CITY OF CODY
PLANNING, ZONING AND ADJUSTMENT BOARD
TUESDAY August 9, 2022
CITY HALL COUNCIL CHAMBERS @ 12:00 NOON

**CITY OF CODY
PLANNING, ZONING AND ADJUSTMENT BOARD
STAFF REPORT**

MEETING DATE:	AUGUST 9, 2022	TYPE OF ACTION NEEDED	
AGENDA ITEM:		P&Z BOARD APPROVAL:	
SUBJECT:	PRELIMINARY PLAT OF THE SCHOONOVER SUBDIVISION. SUB 2021-07	RECOMMENDATION TO COUNCIL:	X
PREPARED BY:	TODD STOWELL, CITY PLANNER	DISCUSSION ONLY:

MEETING DATE:	AUGUST 9, 2022	TYPE OF ACTION NEEDED	
AGENDA ITEM:		P&Z BOARD APPROVAL:	X
SUBJECT:	SITE PLAN REVIEW: SWEET'S SODA SHOPPE. SPR 2022-15	RECOMMENDATION TO COUNCIL:	
PREPARED BY:	TODD STOWELL, CITY PLANNER	DISCUSSION ONLY:

DRAWING NAME: V:\2021\4050 (Lot 102) Minor Subdivision\ACAD\Draw\Survey\24145007 PRELIMINARY PLAT.dwg

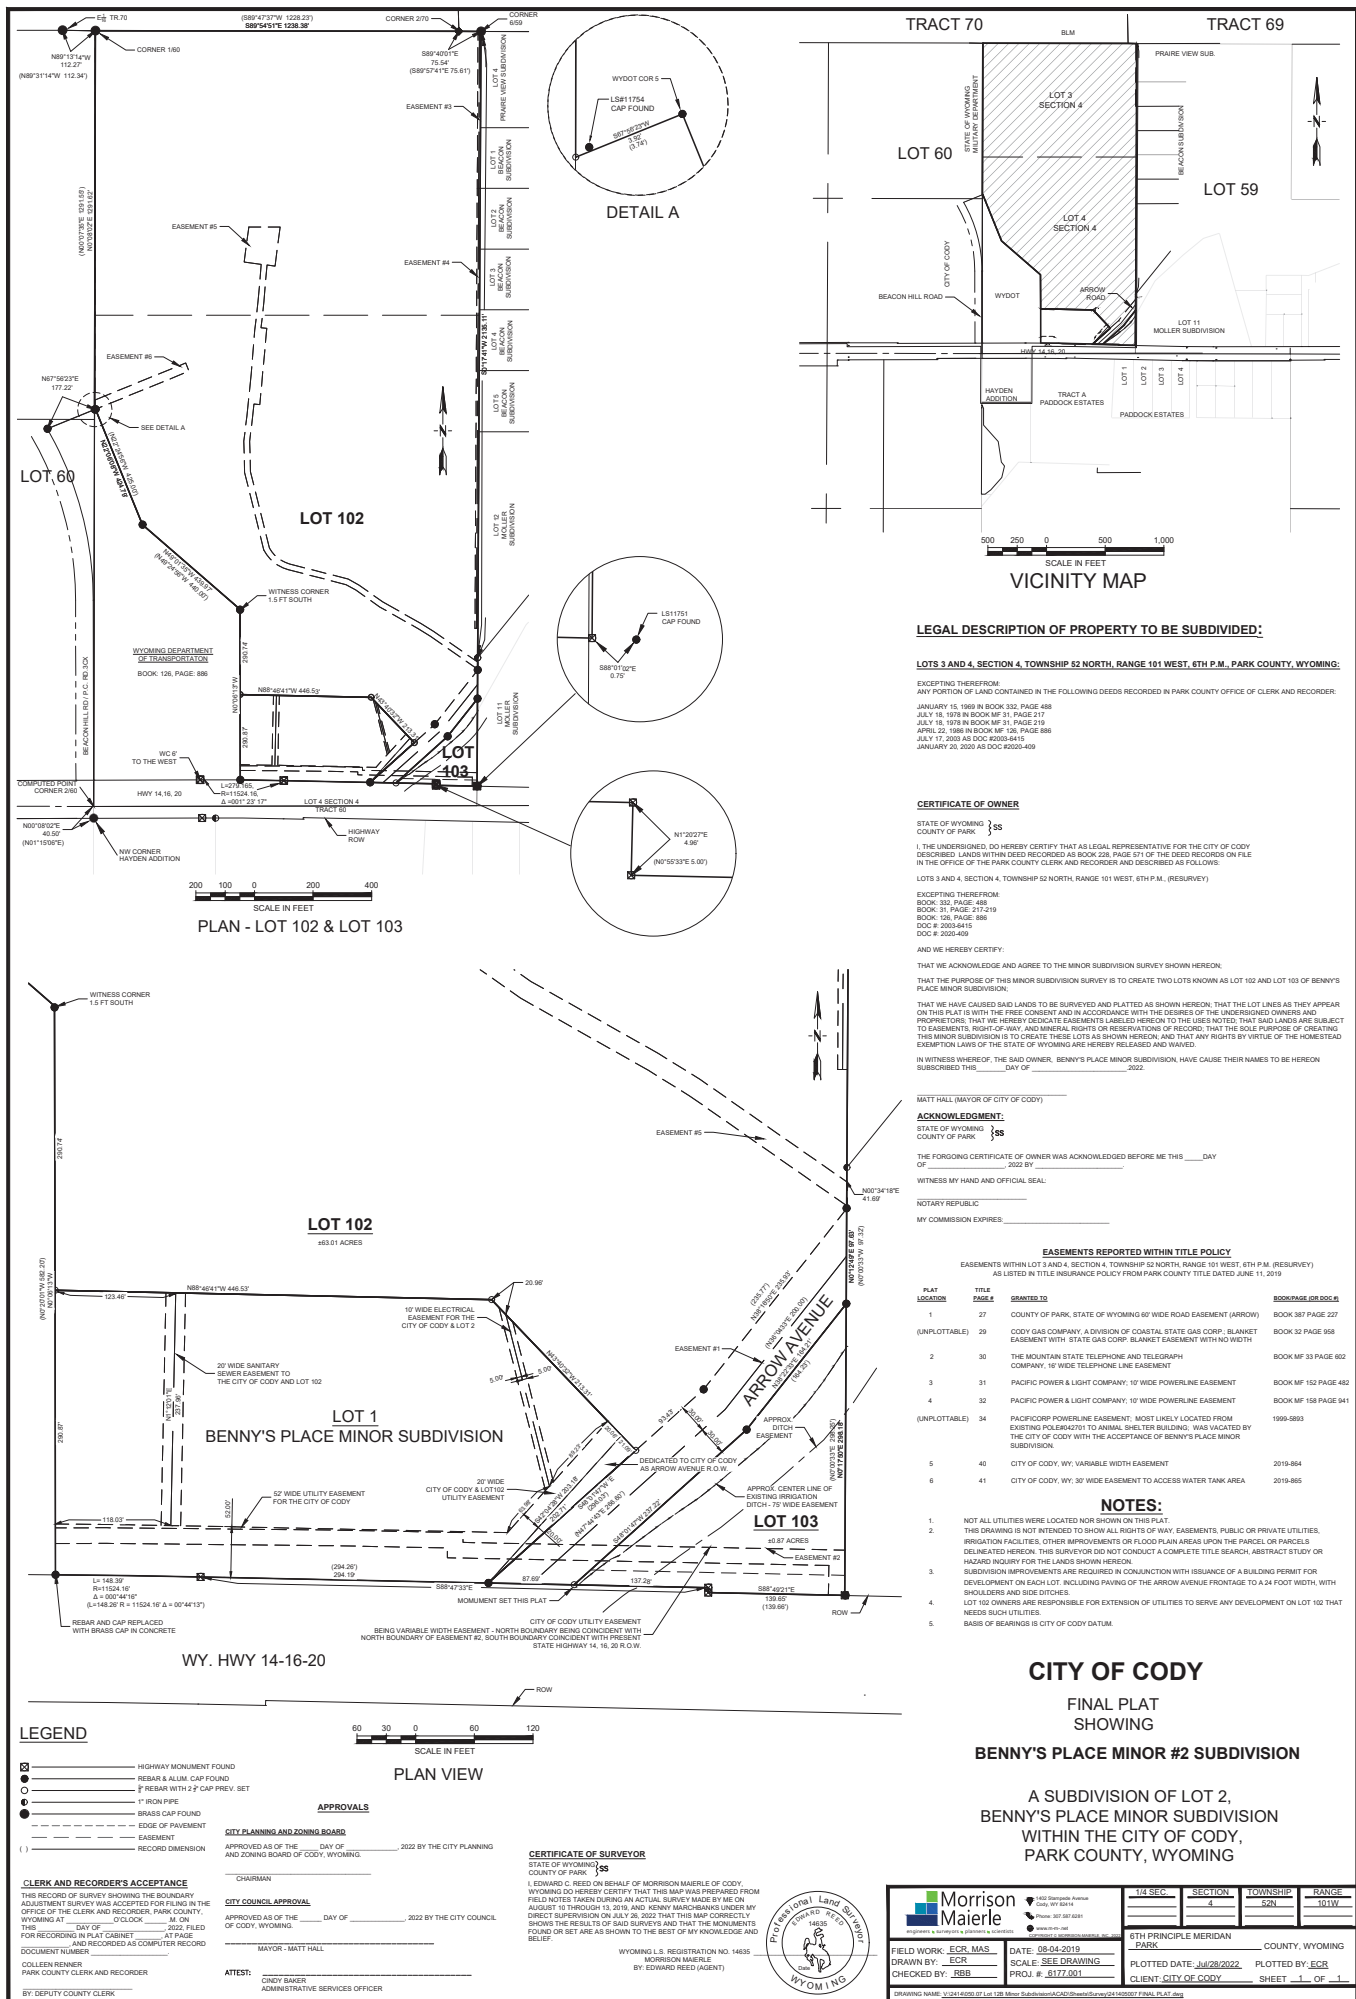
Comments- Arrow Avenue is specified as a "rural" roadway in the city master street plan, which calls for a 32-foot-wide paved road with side ditches. Arrow Avenue is currently a 24-foot-wide gravel road, except for the paved section off of the highway. As Arrow Avenue is maintained by the County, and they specify only a 24-foot-wide gravel surface, we propose a variance be authorized to require only a 24-foot-wide road, with a paved surface and side ditches.

Comment: Due to topography, low pressure grinder pump sewer systems will need to be used for both lots. Lot 102 has an easement across Lot 1 of the Benny's Place Minor Subdivision to access the sewer main. Lot 103 has access to the City low-pressure sewer main on the lot itself. Both lots are to be served with City sewer, but the line sizes are different due to the type of service line (low-pressure instead of gravity).

Comment: There is an open irrigation lateral across Lot 103. Due to the size of the ditch, Cody Canal is not requiring it to be piped by the lot owner. A variance to the requirement is proposed.

1. To waive the alley requirement.
2. To allow a reduced road width for Arrow Avenue from 32' to 24' of pavement.
3. To the requirement to provide install a sidewalk or pathway along Arrow Avenue.
4. To the requirement to pipe the irrigation lateral.

1. Include a note on the final plat that any outstanding subdivision improvements and utility installations are required in conjunction with issuance of a building permit for development on each lot, and to see the Community Development Department for details.
2. Include a note on the final plat that vehicle access for Lot 103 is to be from Arrow Avenue, and located at least as far back from the highway as the access to animal shelter, unless authorized otherwise by Public Works.

SITE PLAN

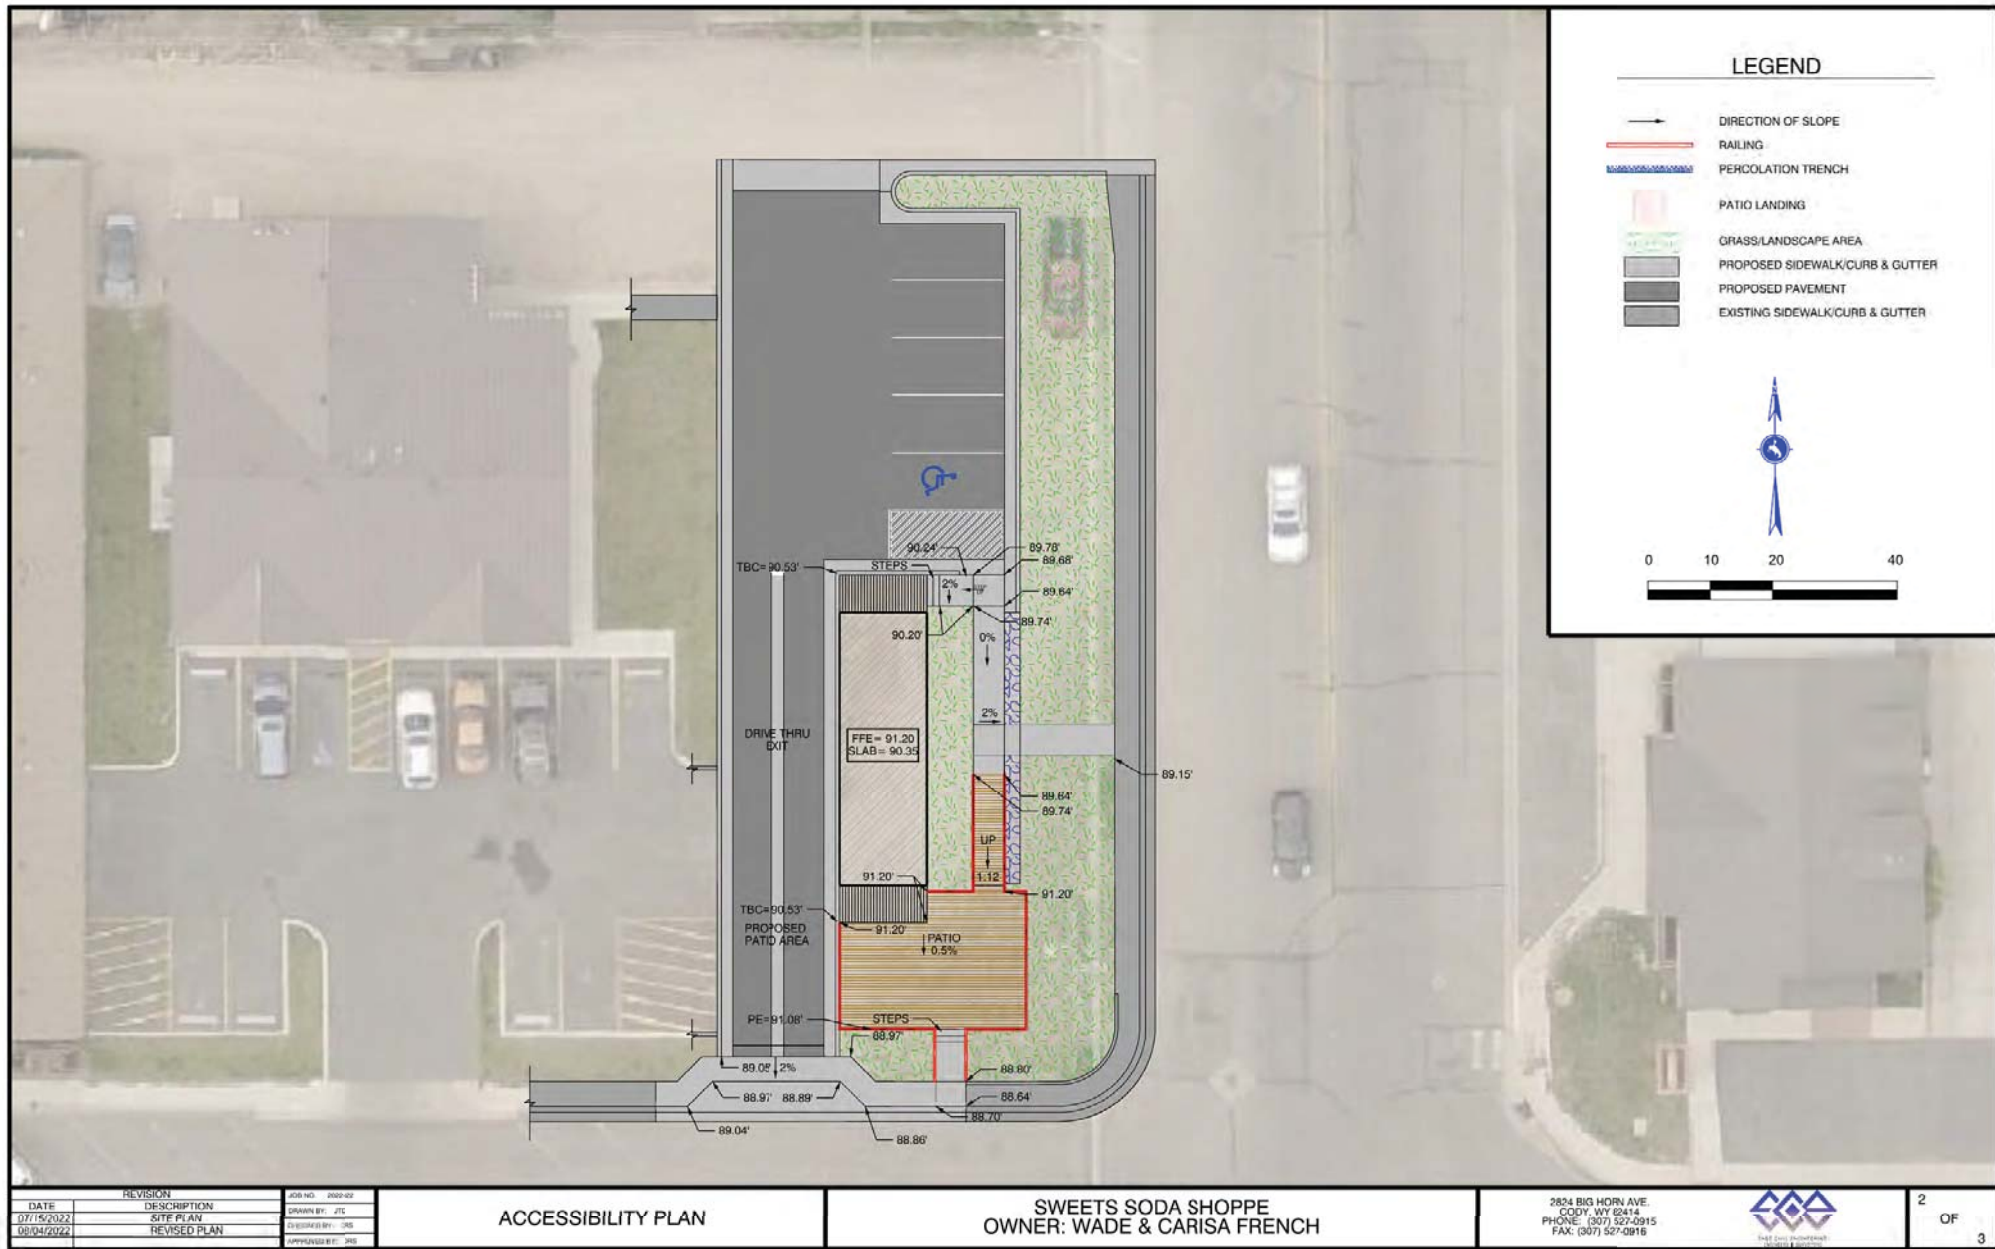
The proposed access layout is shown on the attached civil site plan by Sage Civil Engineering, and is acceptable to public works. Access to the parking spaces and drive thru would be from the alley to the north of the property. Vehicles would exit through the drive thru route, which is marked appropriately as a right turn only, or through the alley to 19th Street. The drive-thru lane is just wide enough that a standard passenger vehicle could fit around another vehicle stopped at the drive-up window.

The ADA parking and unloading space is shown as required. Being a van-accessible space, the striping can be done to create an 11-foot-wide parking space and 5-foot-wide unloading aisle (reduces cross hatched area). A sign in front of the ADA space will need to be added.

The site plan shows five standard parking spaces. In practice, we have counted the vehicle stacking area of the drive through lane (at one space per 22') as counting as parking spaces also. This site plan has stacking for five spaces in the drive thru lane, for a total of ten parking "spaces".

The connection locations for sewer, water, and natural gas are shown appropriately on the site plan. The water tap will need to be made on the far side of 19th Street. Usually, the water crew does the work to tap the line and bring it to the property line. However, in this case, due to scheduling, etc., they may determine that the excavation and asphalt patching be done by contractors. Coordinate with Public Works. Applicable utility fees will need to be paid for the utility connections.

3. Modify the landscaping plan to provide the required clearances from the electrical boxes.
4. An "Exit Only" sign must be installed facing Sheridan Avenue, and on the back side of the post, a "Right Turn Only" sign installed.

PLANT LEGEND:

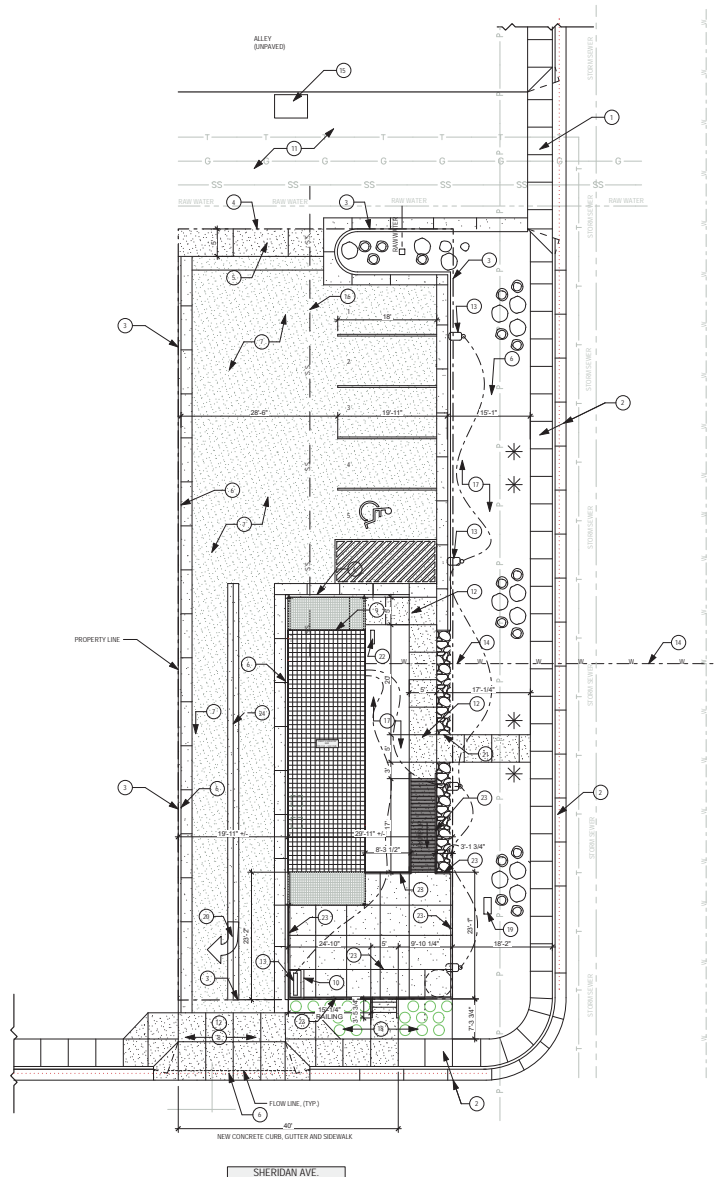
The landscaping plan is attached. It proposes a combination of grass lawn, feather reed grass, weigela, euonymus, and dwarf Alberta spruce. The landscape plants are generally climate appropriate and will greatly enhance the presentation of the property. (My weigela plants die back to ground level each winter, so they never get very large.)

All vegetation will need to be located so that it does not grow into the sidewalk area, and maintains clearances from the electrical cabinet near the intersection. Refer to the following diagram from the City of Cody Electrical Distribution Standards Manual, section 9.02. For electrical cabinets $z=3'$ and $x=10'$. The southern cluster of plants along 19th Street will need shifted to provide the clearances.
